Item: 22-257 Discussion of Statement of Direction Andaz Resort Intermediate Special Use Permit Amendment 6160 N Scottsdale Rd & 6041 N Quail Run Rd 45 Minutes

6401 E. Lincoln Drive
Paradise Valley, Arizona 85253
RE: 6041 N. Quail Run Road – Proposed Andaz Resort Expansion

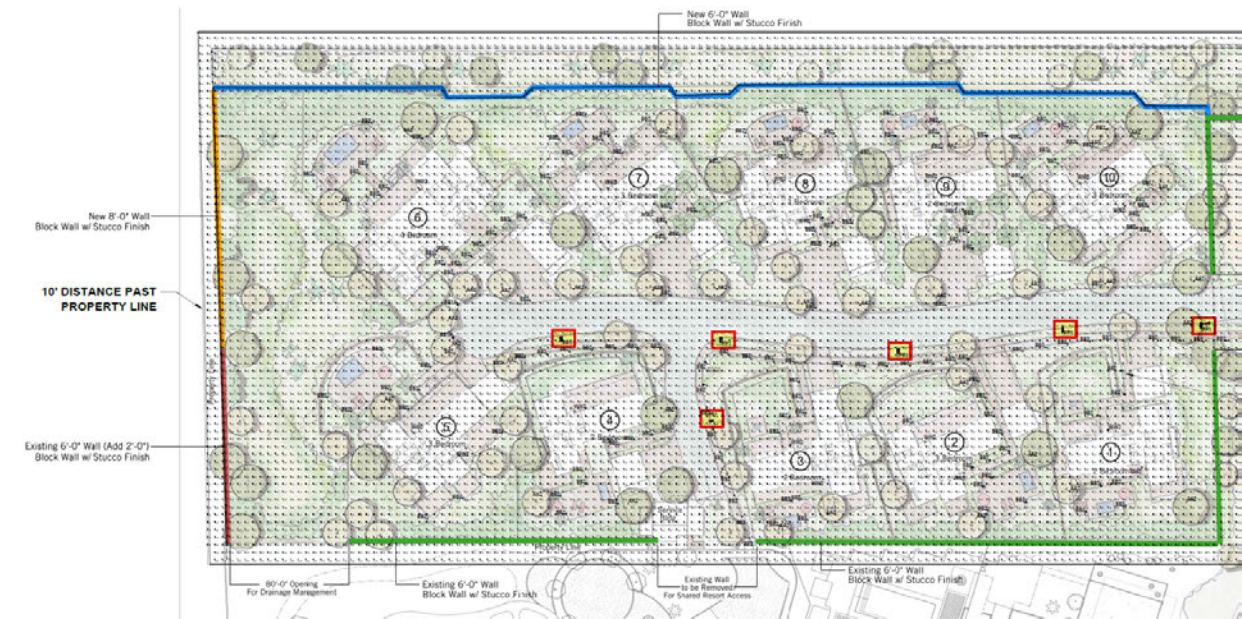
They are using the same light fixtures that are on the existing campus. 6 light poles will be placed along the new drive aisle and the guest unit sconces will be limited to a height of 7'6" tall from

finished grade (see below) I don't know if you will be able to see any light above your fence wall, however, the light fixtures are compliant with Town Code
